**MCDOWELL COUNTY SCHOOLS  
MCDOWELL COUNTY, WEST VIRGINIA  
FALL RIVER ELEMENTARY WINDOW AND DOOR REPLACEMENT & MOUNT VIEW  
HIGH RESTROOM RENOVATIONS  
ADDENDUM #3  
December 2, 2021  
THRASHER PROJECT #060-10246**

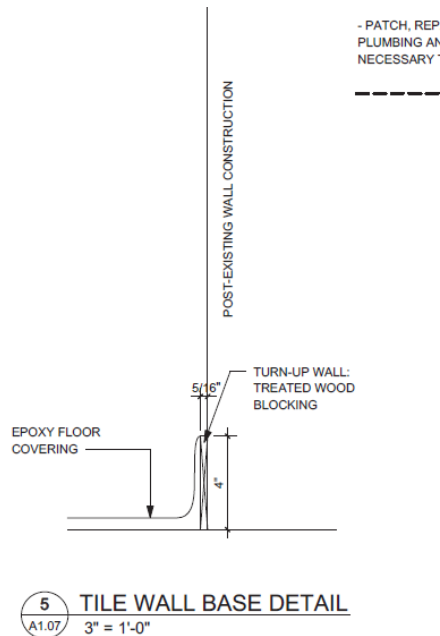
9. 5/16" Treated Wood Blocking would be hard to come by. The material would need to be run through a planner, adding additional costs to the application. Is 1/4" cement board acceptable?

Yes.

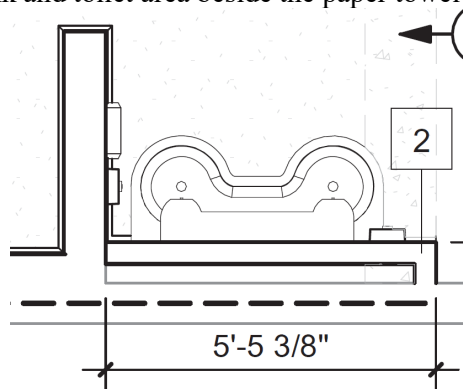
12. 3/A4.02 - Interior Elevation - Restroom 209 - Does not show a mirror. Is a mirror required?

No.

1  
E2.01R1  
ENLARGED POWER PLAN - RESTROOMS 101, 102, 201, 202, 301, 302, (401 & 402 ALTERNATE #1)  
1/4" = 1'-0"

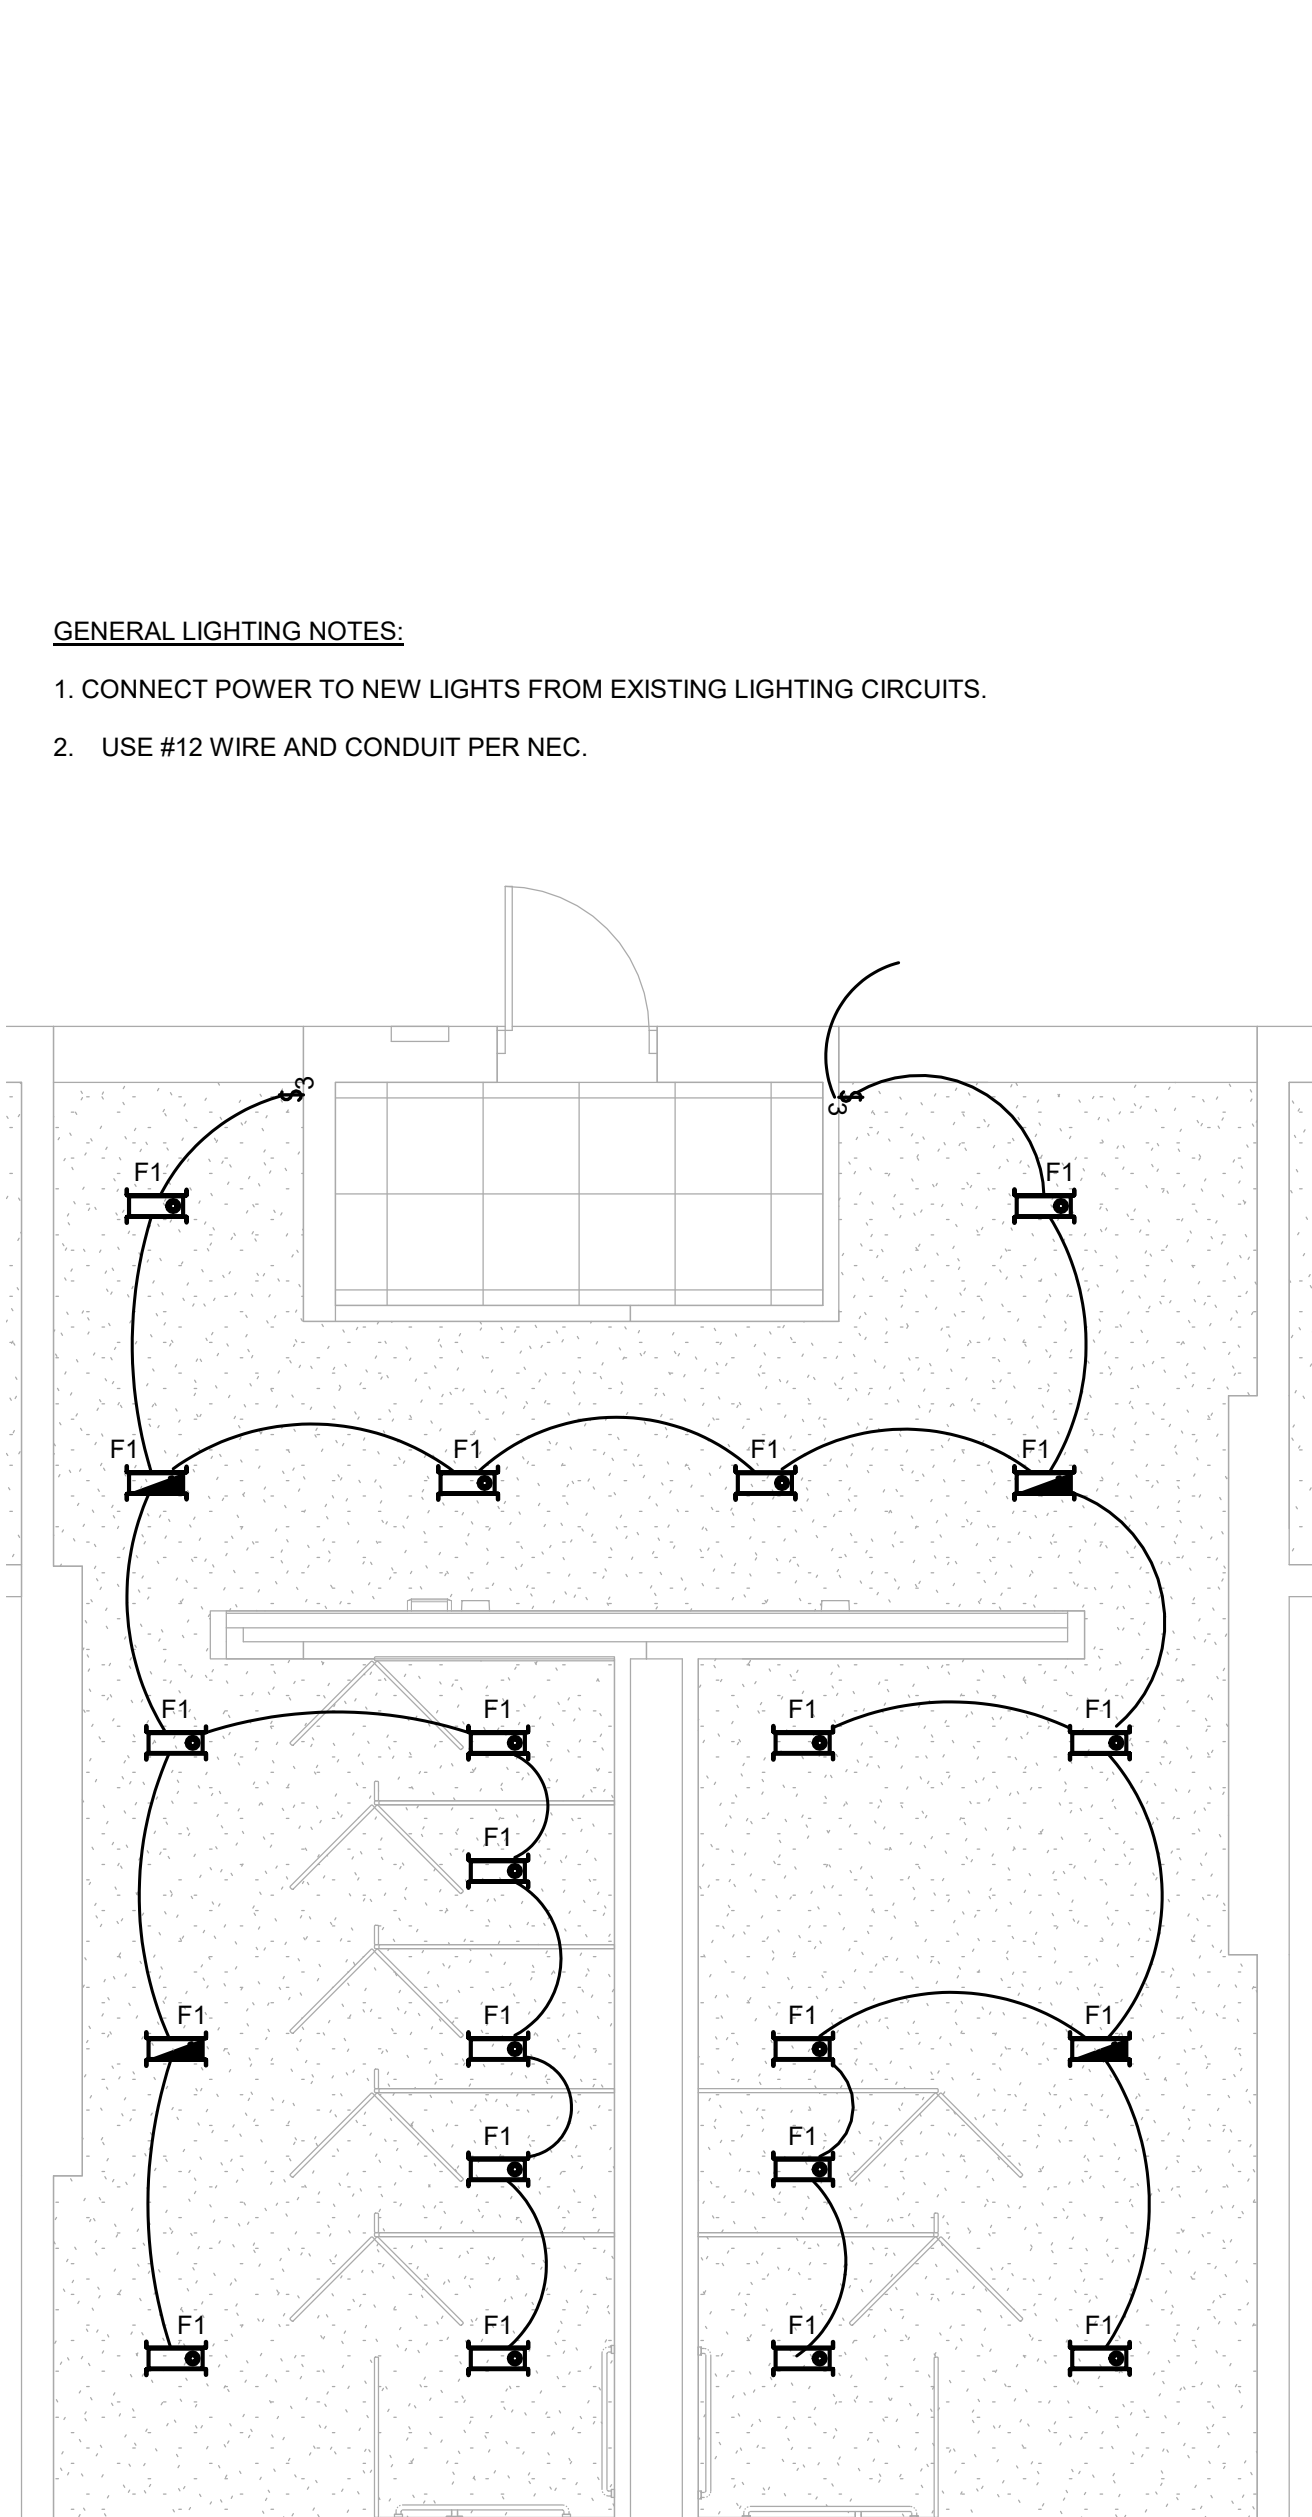
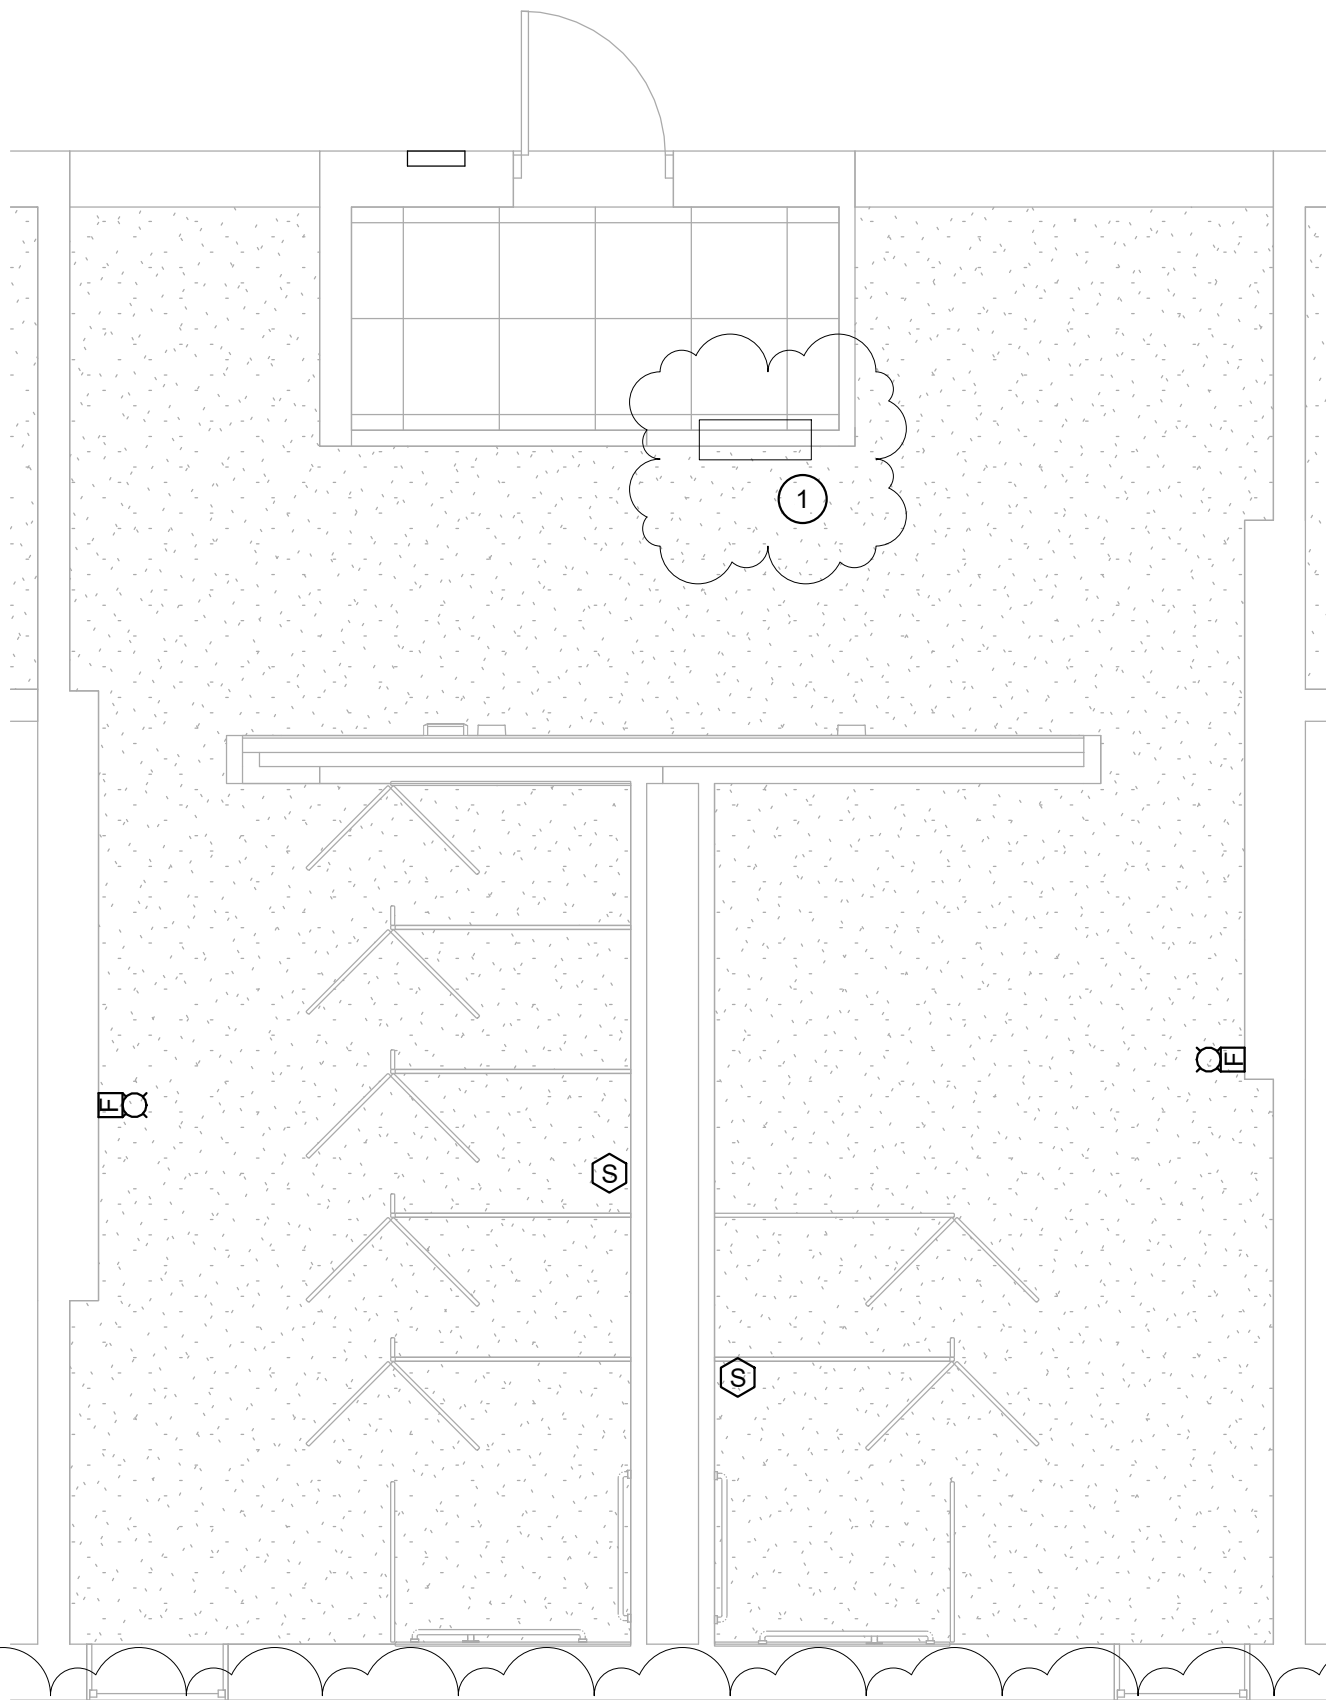
**33.** Fire Dampers – Where can I find the requirements in the bidding documents for fire dampers, both HVAC & Electrical Requirement?

See revised plan sheets M3.01R1, M5.01R1 and E2.01R1.

POWER PLAN KEYNOTES	
NOTE #	DESCRIPTION
1	RESTROOMS 101, 102, 201, 202, 301, & 302 PROVIDE 120V TO SMOKE DAMPER MOTOR FROM NEAREST AVAILABLE 120V SOURCE. RESTROOMS 401 & 402 PROVIDE 120V FOR 3 SMOKE DAMPER MOTORS FROM NEAREST 120V SOURCE. EACH CIRCUIT USED SHALL BE LABELED AS SMOKE DAMPER IN THE PANEL.

M3.01R1

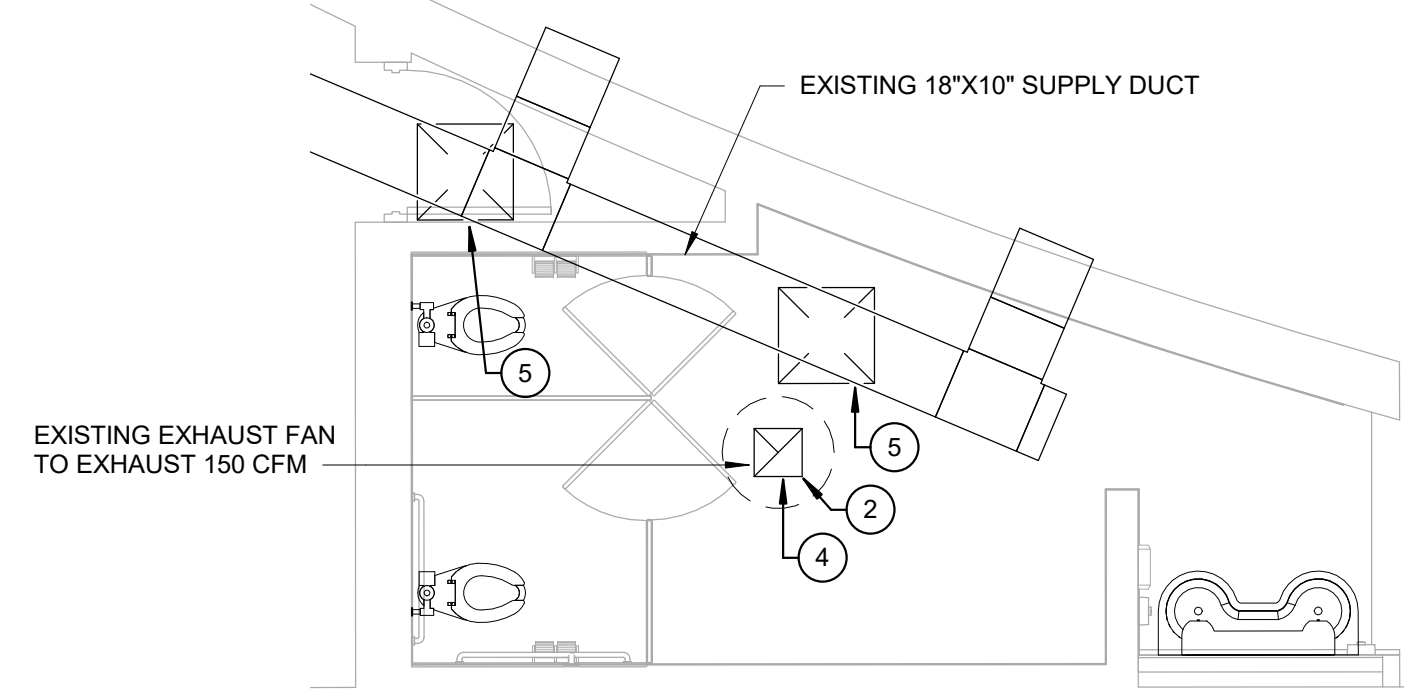
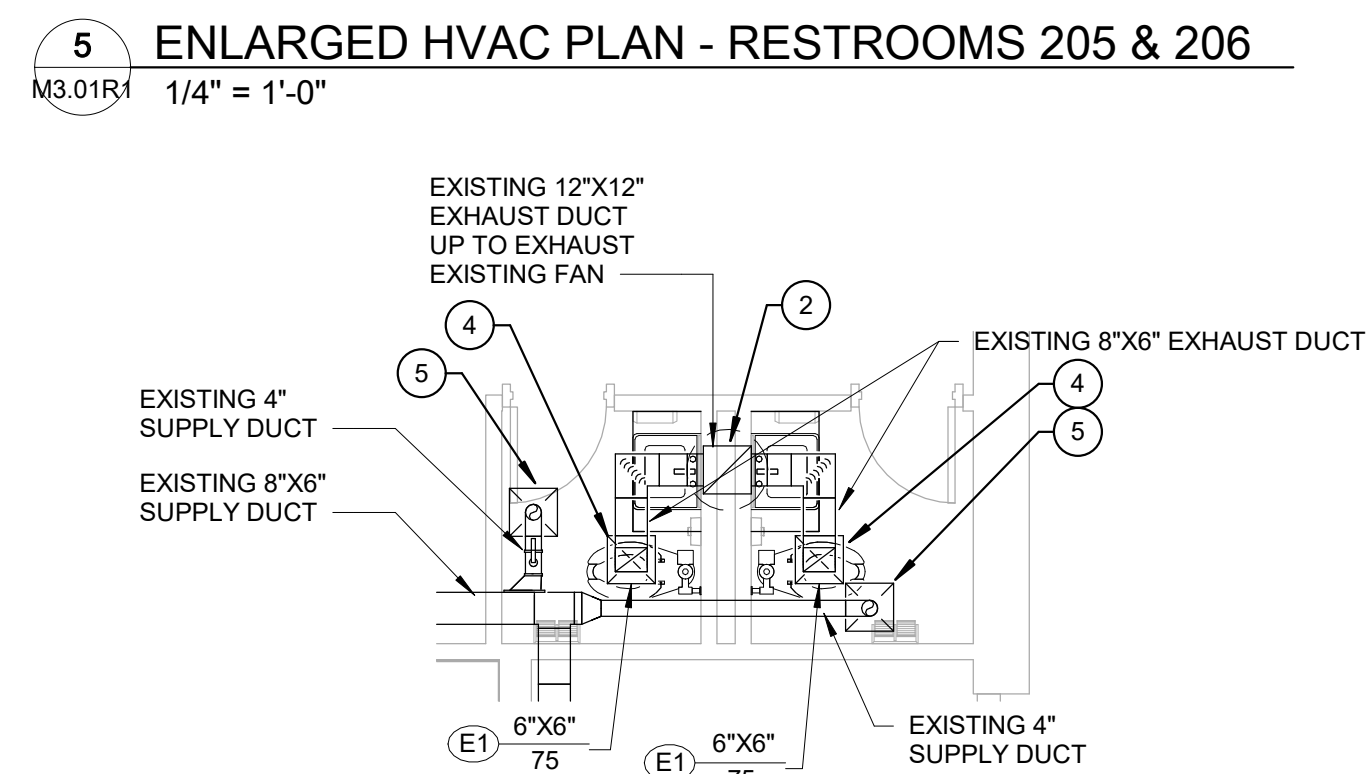
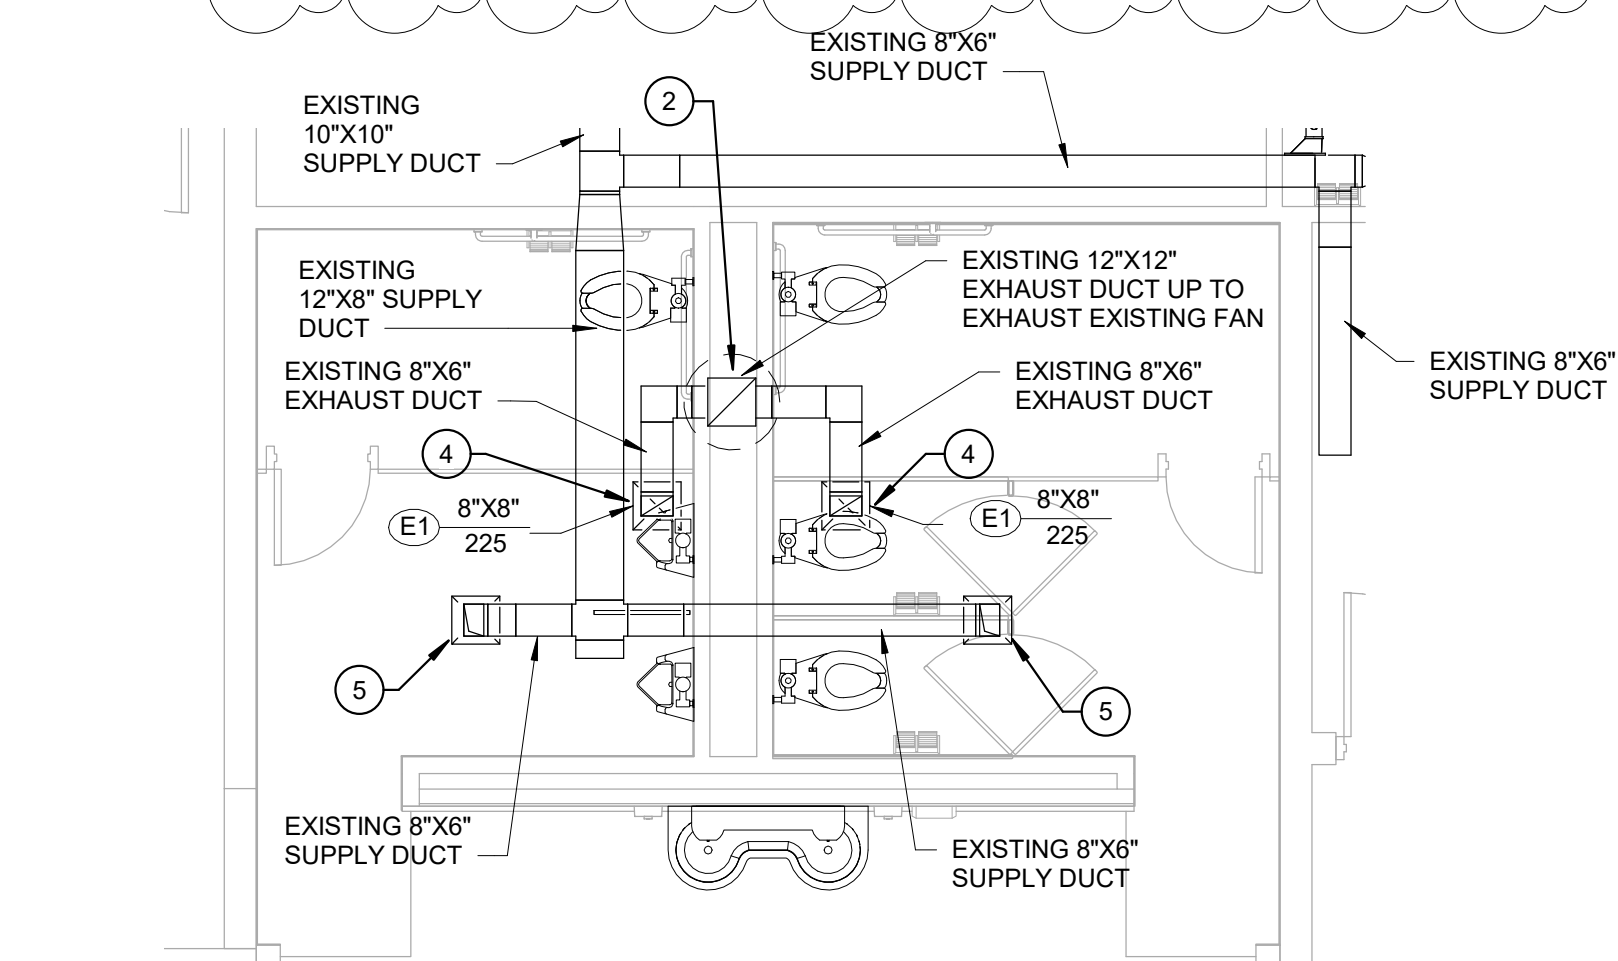
**34.** Fire Dampers – Should fire dampers be installed in the duct work will penetrating through the floor or fire wall?

See revised plan sheets M3.01R1, M5.01R1 and E2.01R1.
